Exeter City Council Planning Committee 28 April 2025

Application 25/0072/LBC

Site: 25 The Strand, Topsham

Proposal: Roof and floor repairs. External masonry and wall repairs; re-building of parapet. Replacement of 20th Century windows in sail loft. Removal of external wall cement rendering and replacement with lime render. Replacement of 20th Century fixed slatted shutters on south elevation.

Roof repairs

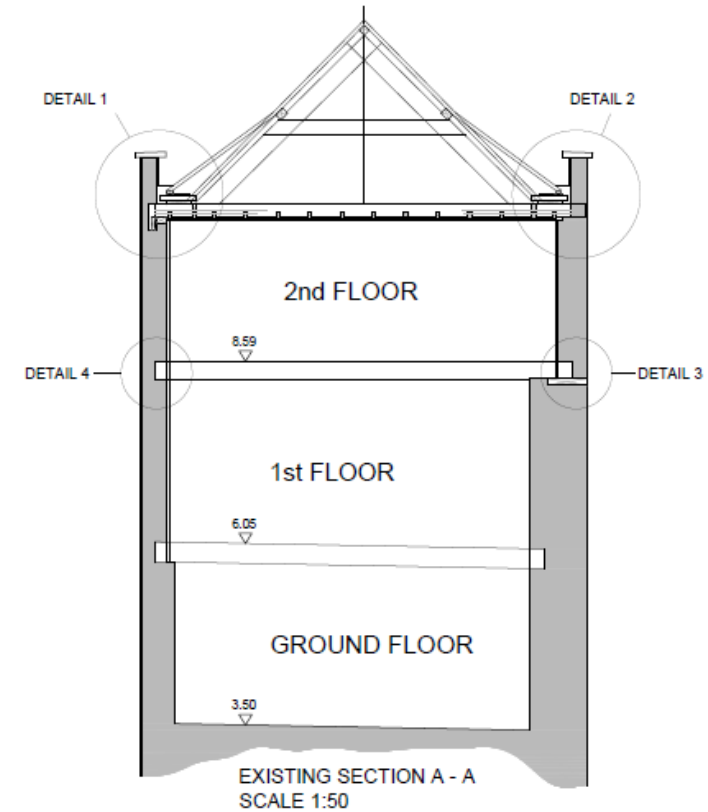
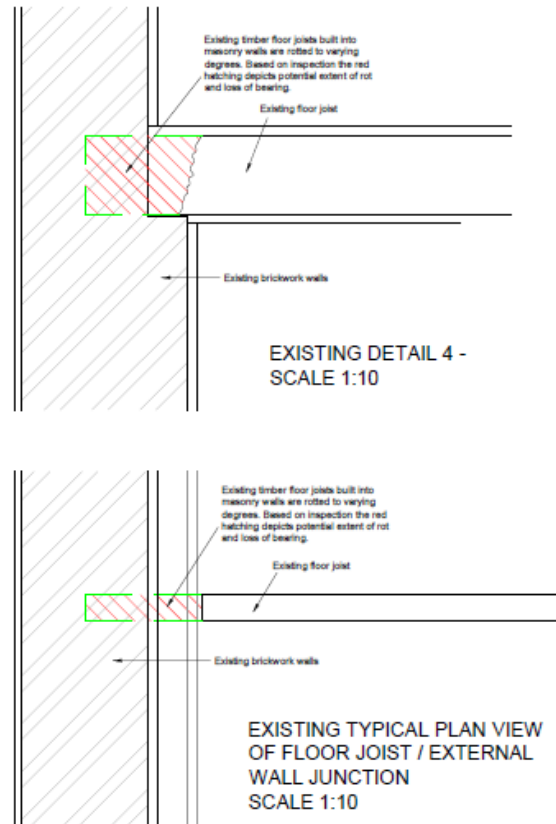
The need for repairs to the roof trusses [...] is also clear, but we have concerns about the proposed methods. The roof trusses may date to 1739 and are certainly C18, but it is not confirmed whether the ceiling joists are contemporary to the trusses or later additions. They are bolted to the truss chords at present but support a lath and plaster ceiling which invites further assessment: the ceiling joists are likely historic, if not original. The interventions as proposed would require the cutting back of these joists in, by our calculations, at least 32 locations. The trimmed joists would then be hung off joist hangers. This change is required as a direct result of the proposed interventions to stabilise the junction between the truss cords and the wallhead by encapsulating the ends of the chords in a timber boot. The boot would have the further negative impact of obscuring the chamfered edges of the cords (albeit within the attic space).

In our view that a more elegant solution is likely available which addresses the structural issues whilst requiring a less bulky and visually cumbersome addition and avoiding the need to cut away so much of the ceiling joists. We recommend that the applicant engages a CARE accredited engineer to advise in this matter, and that further investigation is made as to the age and significance of the ceiling joists.

- The roof and ceiling joists are the same age as the main roof structure.
- Some loss of ceiling joist ends, however, the great majority of ceiling joist ends will remain wholly undisturbed.
- Repair avoids disturbance of the joints of the main timbers and avoids changing the way the main roof structure functions.
- SPAB raises concerns about obscuring the chamfered beam ends; Officer view - minimal and rudimentary chamfering or no chamfering.
- The applicant has sought advice from appropriately qualified and experienced specialists. CARE accreditation is not an essential requirement
- The proposed repair is an acceptable approach to resolving the problem.

The benefit of ensuring the structural stability of the roof is considered to outweigh the small amount of harm arising from the loss of some ceiling joist ends.

Floor joist repairs

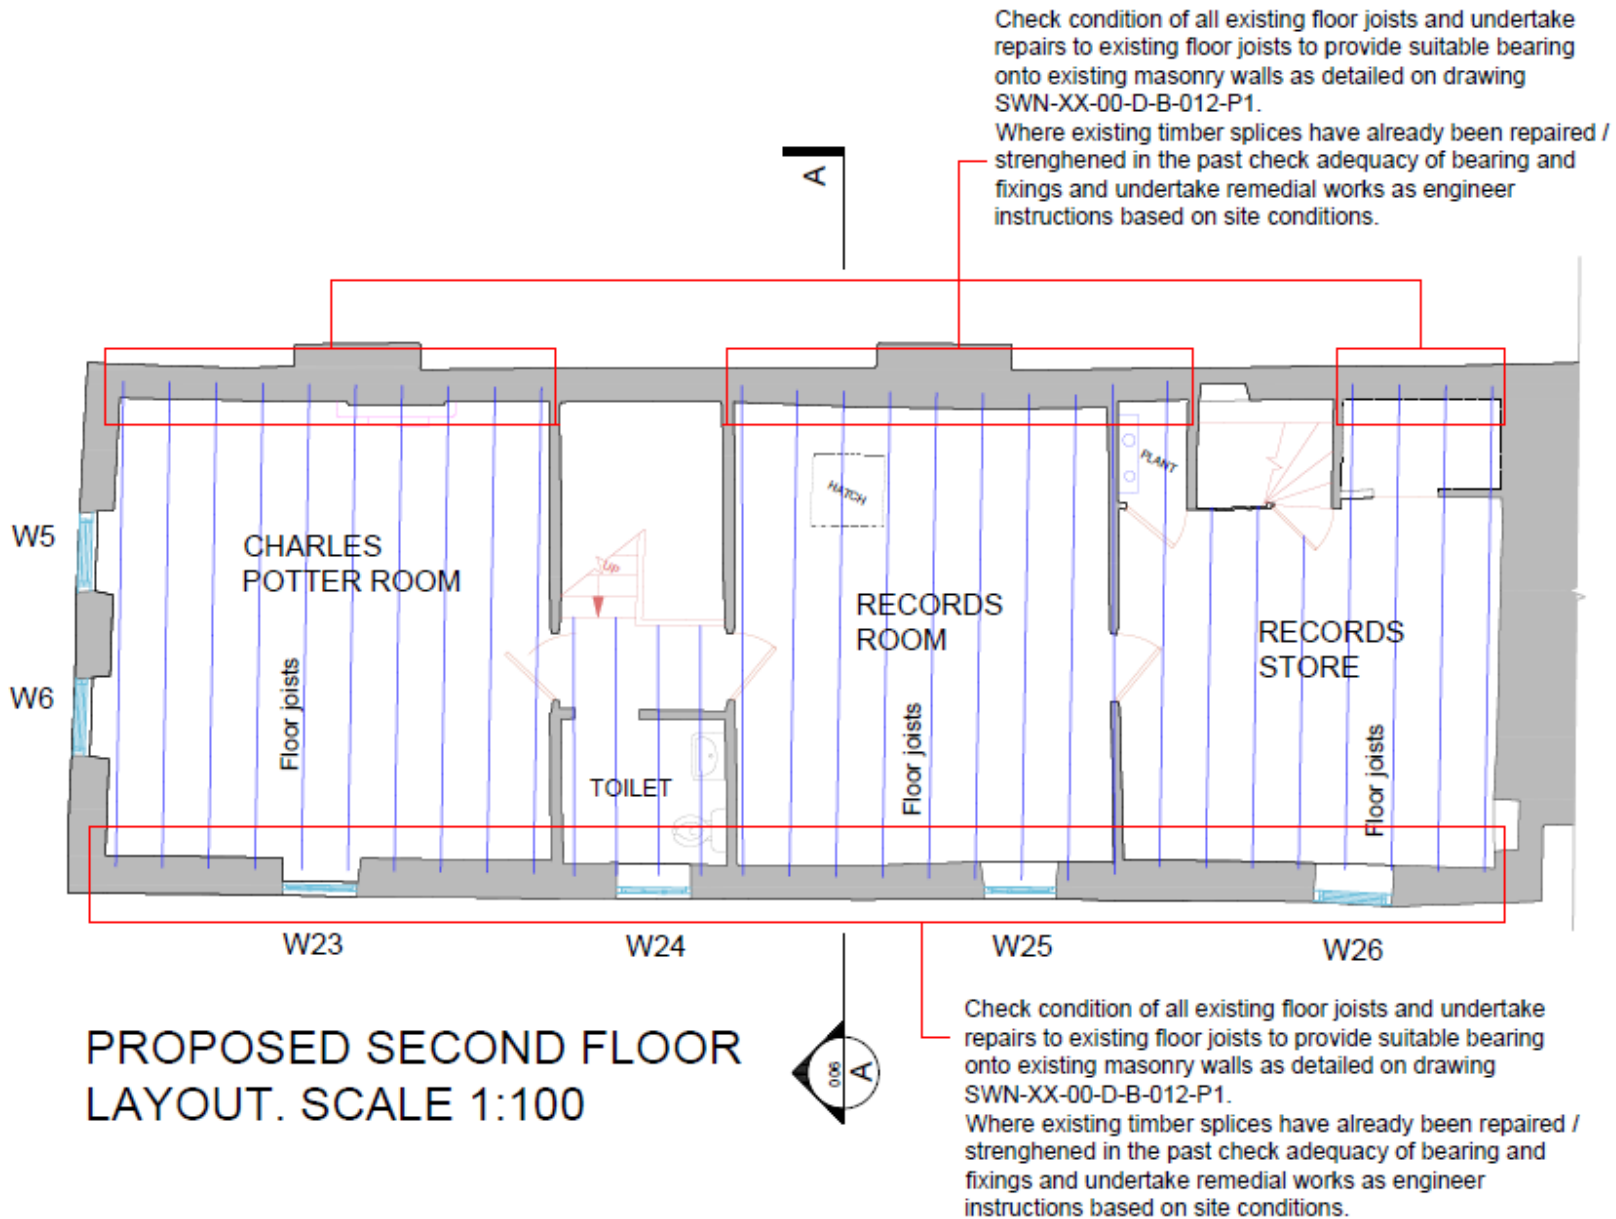
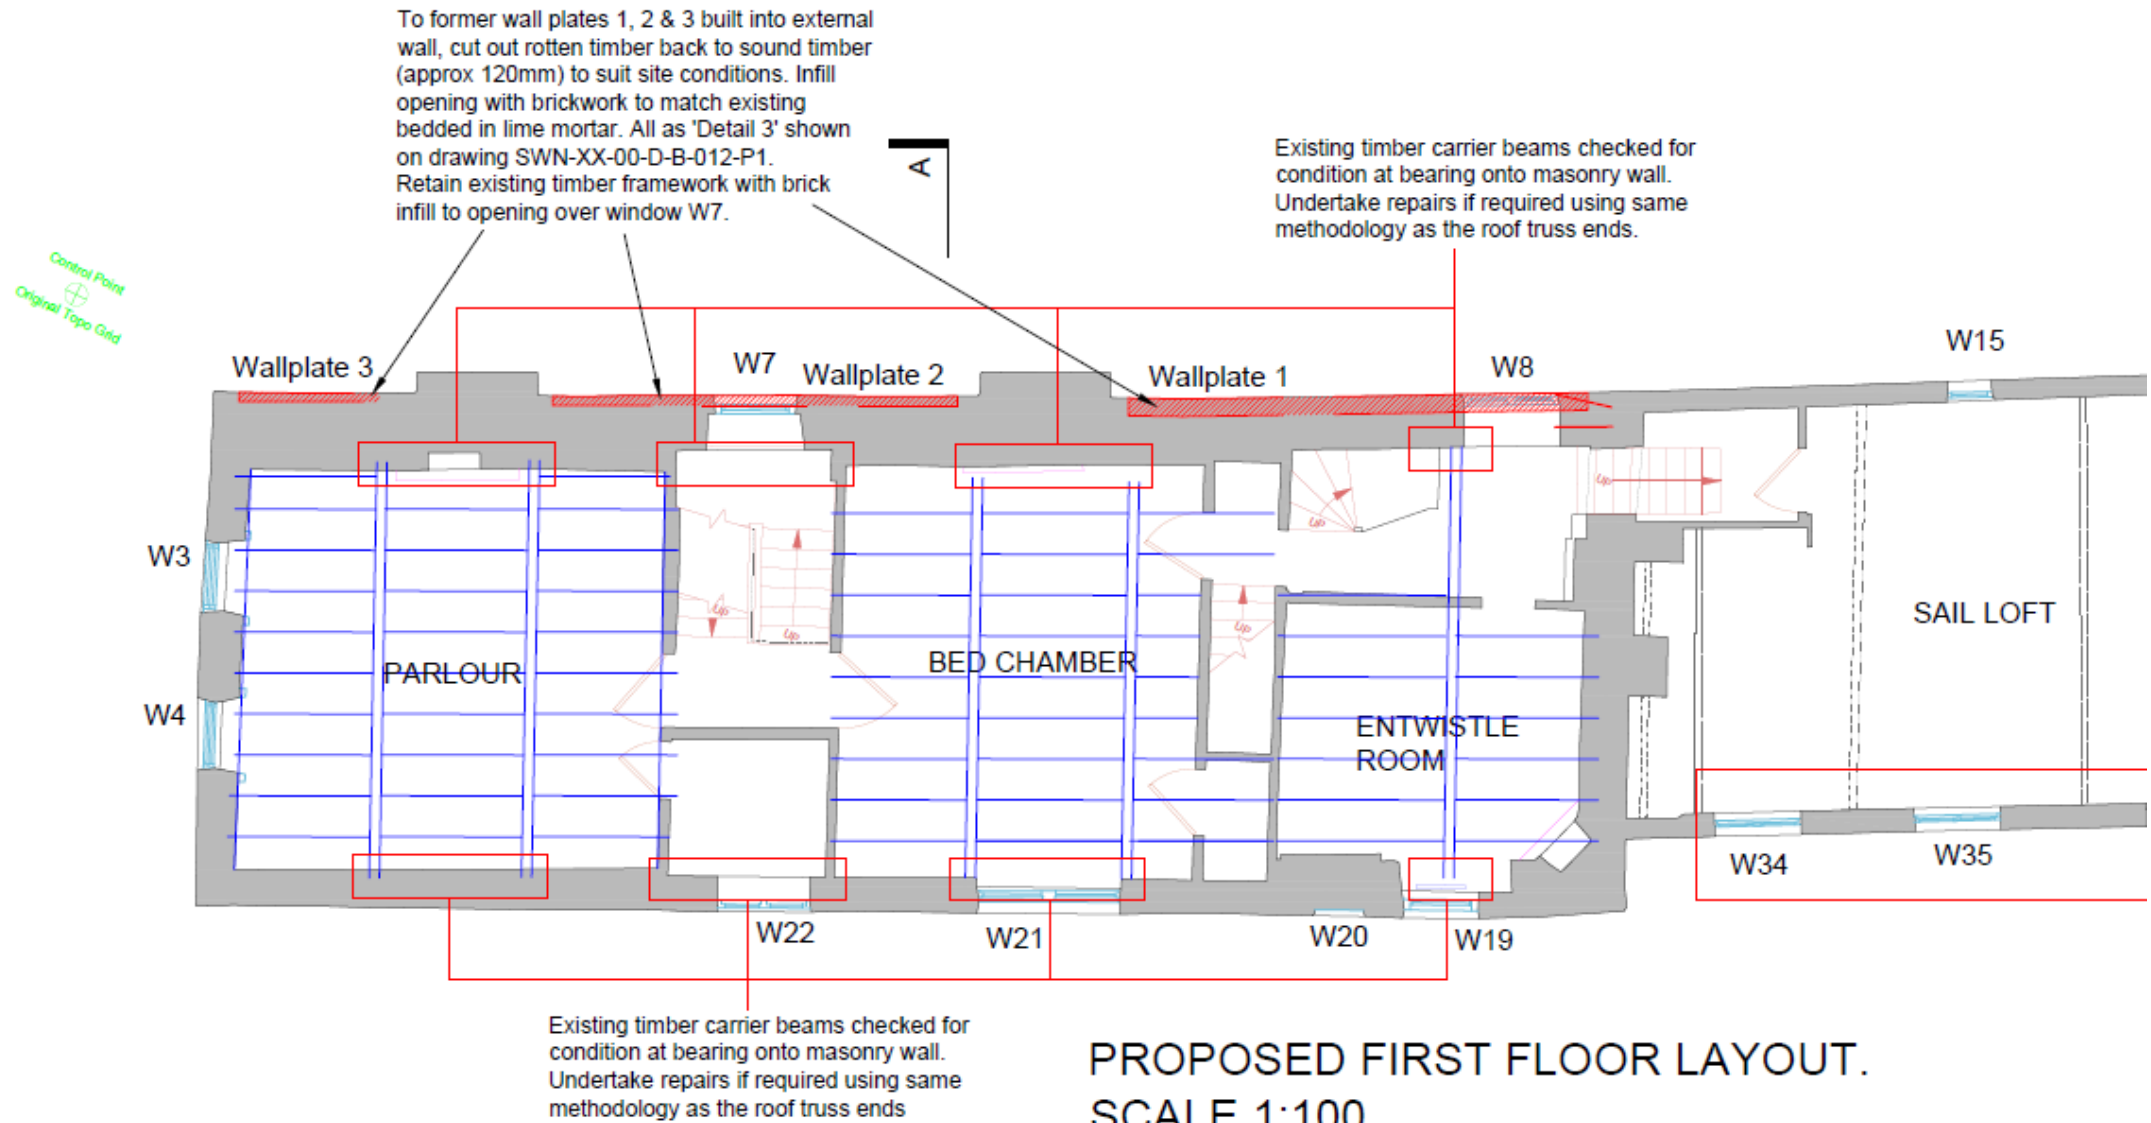
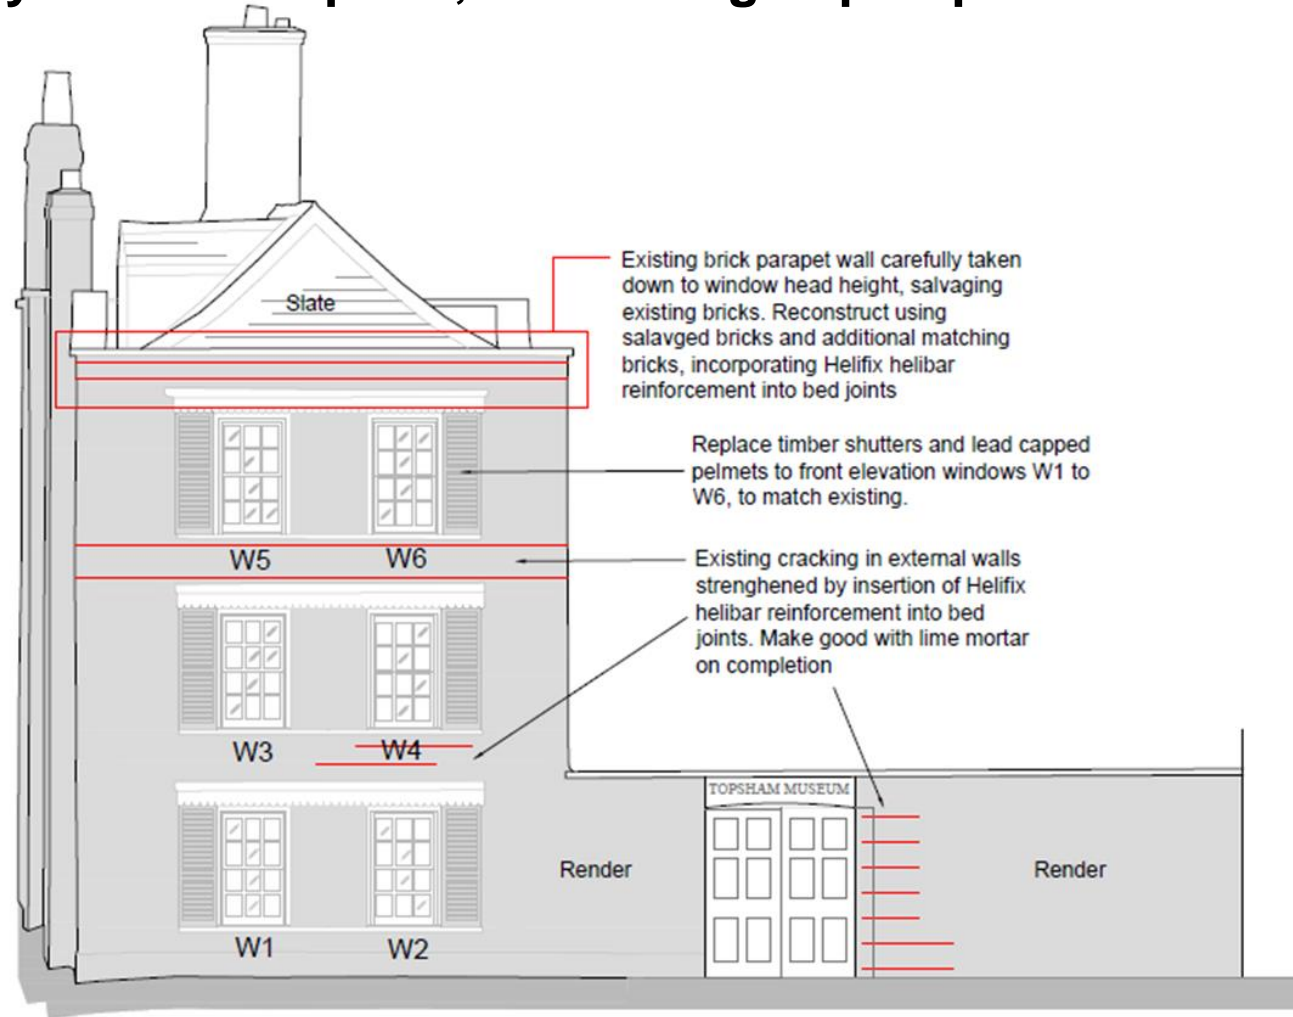
The need for structural repairs at the first and second floors in the south-west range is clear, and our preference for the works to the floor joists would be to employ steel angles. These offer a neater method by which to tie the floor joists to the walls when compared to the option utilising timber.

- Repair methods for the floor joist ends are considered to be acceptable
- Proposal - Two specific repair methods, which will be selected depending on the situation and extent of decay in each joist end.

SPAB has expressed a preference for just one of the proposed repair methods.

- Where a timber repair is a practical option without excess disturbance of historic fabric in the external wall, it is considered to be more appropriate than a repair using steel angles bolted to the inner faces of the masonry walls.
- Officer advice is that **timber repairs are appropriate** and justified, with use of steel angles as a reserve option where timber repair is not possible.

- Replacement of windows in sail loft

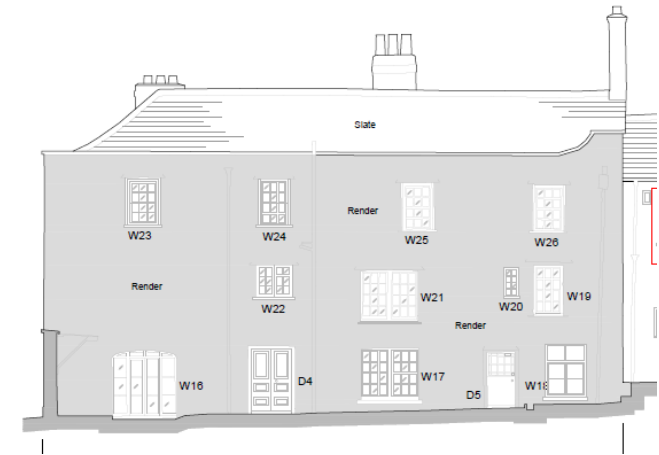
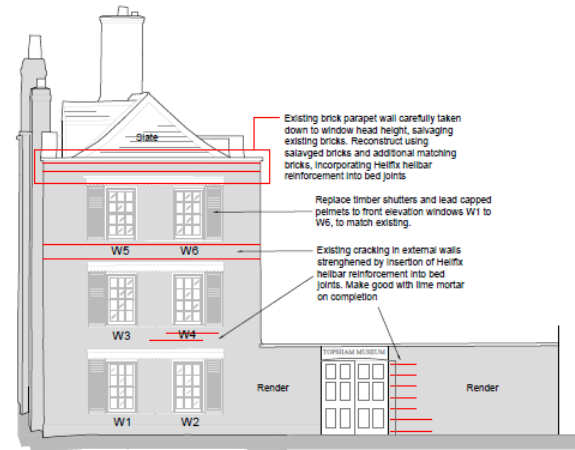
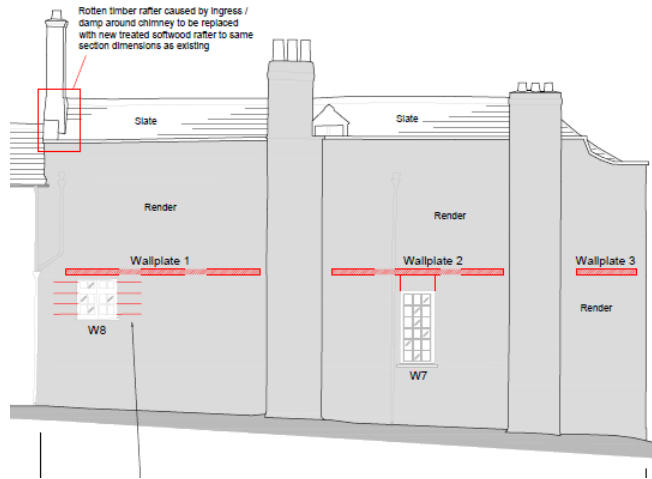
Considering the 6 no. south-east facing windows at first floor level in the central Victorian range (sail loft), and the shutters and pelmets to the front elevation, we would have hoped to see a greater assessment of the age and significance of these elements within the application. As their significance has not been made clear, it is our view that the application has not yet satisfied paragraph 217 of the National Planning Policy Framework (NPPF) which requires applicants 'to describe the significance of any heritage assets affected' by proposals. Additional information is required to address this.

The application confirms that repair of the windows is feasible, and so their replacement would not be supported unless it can be demonstrated that these are modern introductions. Regarding the shutters and pelmets, the significance and condition of these elements should be made clear, so that an assessment can be made as to whether their replacement is appropriate.

- The sail loft windows proposed for replacement are themselves replacements **dating from the 1980s** and are not historic.
- The timber of the 1980s windows was not high quality and has reached the end of its useful life. Repair is not a realistic option.
- The historic windows elsewhere in the building were made of high quality slow-grown timber and do not need to be replaced. They will be repaired by a specialist joiner, with new timber scarfed in to replaced decayed sections.
- Officer advice is that **sufficient information** has been provided by the applicant to satisfy paragraph 217 of the NPPF, the windows proposed for replacement are of low significance, and the proposed replacement windows will have a neutral impact on the significance of the listed building.

- Replacement of 20th Century fixed slatted shutters on south elevation

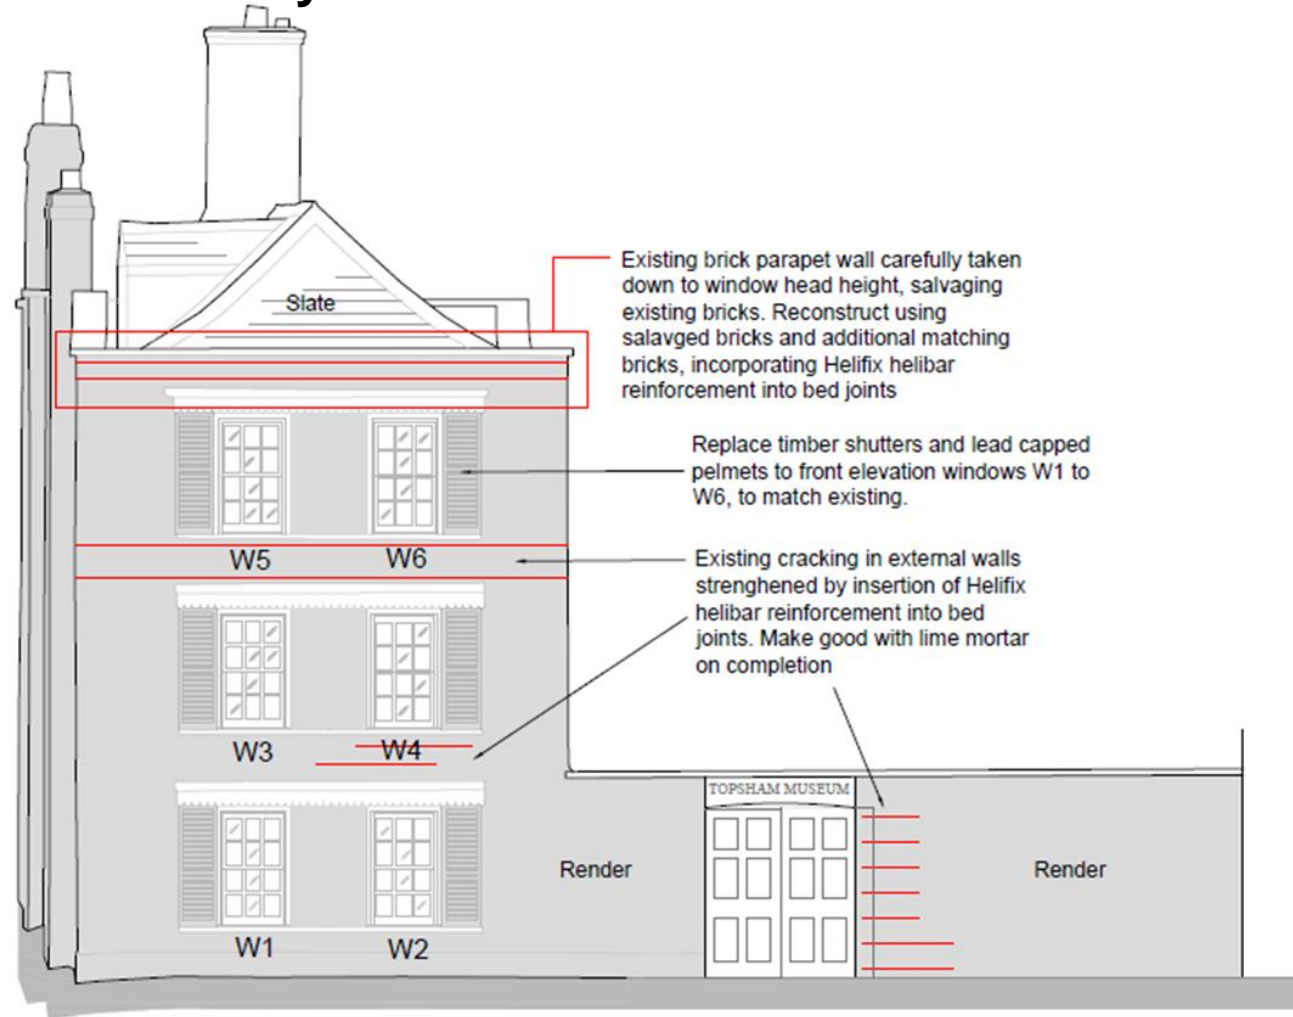
Regarding the shutters and pelmets, the significance and condition of these elements should be made clear, so that an assessment can be made as to whether their replacement is appropriate.
